Access Compliance Report

Public Rights-of-Way

Intersection ID: 10021306	Main Street: BLAIREBETH_ST	Cross Street: N/A	Location: S
ADA ID: E2AABDCC79A0	Ramp Type: BlendTrans1	Initial Pass/Fail: Fail	Overall Compliance: No
		Severity Score: 1.25

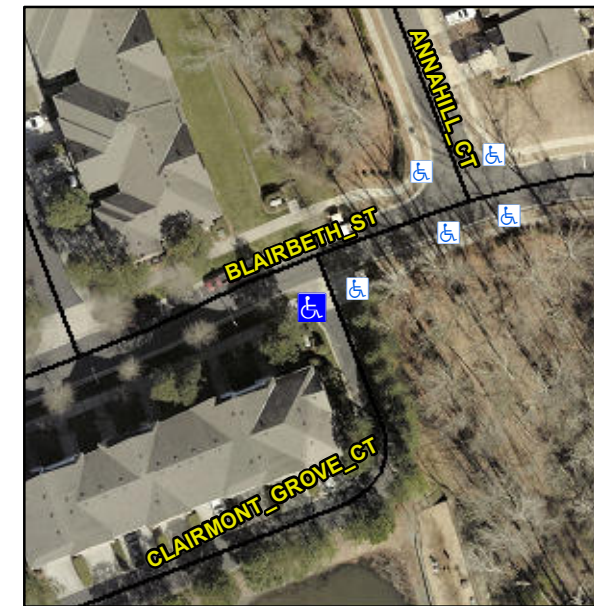
R304.5.3

Compliance	Description	Data	Compliance	Description	Data
N/A	Ramp Length (in)	68.0	Yes	BlendTrans Slope (%)	1.7
Yes	Ramp Width (in)	72.0	No	BlendTrans XSlope (%)	3.1
N/A	Flare Type LT	N/A	N/A	Flare Type RT	N/A
N/A	Flare Slope LT (%)	N/A	N/A	Flare Slope RT (%)	N/A
N/A	Flare Traversable LT?	N/A	N/A	Flare Traversable RT?	N/A
N/A	Landing Length (in)	N/A	N/A	DWS Provided?	N/A
N/A	Landing Width (in)	N/A	N/A	DWS Contrast?	N/A
N/A	Landing Slope (%)	N/A	N/A	DWS Length (in)	N/A
N/A	Landing X Slope (%)	N/A	N/A	DWS Full Width?	N/A
N/A	Landing Curb? (Y/N)	N/A	N/A	DWS Offset (in)	N/A
N/A	Shared Landing?	N/A			
N/A	Gutter Ponding?	N/A	N/A	Gutter Slope (%)	N/A
N/A	Gutter Lip Ht (in)	N/A	N/A	Gutter X Slope (%)	N/A
N/A	Painted X Walk1?	No	N/A	Painted X Walk2?	N/A
	X Walk 1 Direction	To NE		X Walk 2 Direction	N/A
	X Walk 1 Width (in)	N/A		X Walk 2 Width (in)	N/A
	X Walk 1 Slope (%)	0.8		X Walk 2 Slope (%)	N/A
	X Walk 1 X Slope (%)	3.4		X Walk 2 X Slope (%)	N/A

Remove & Replace Curb Ramp With Two New Directional Ramps or Equivalent.
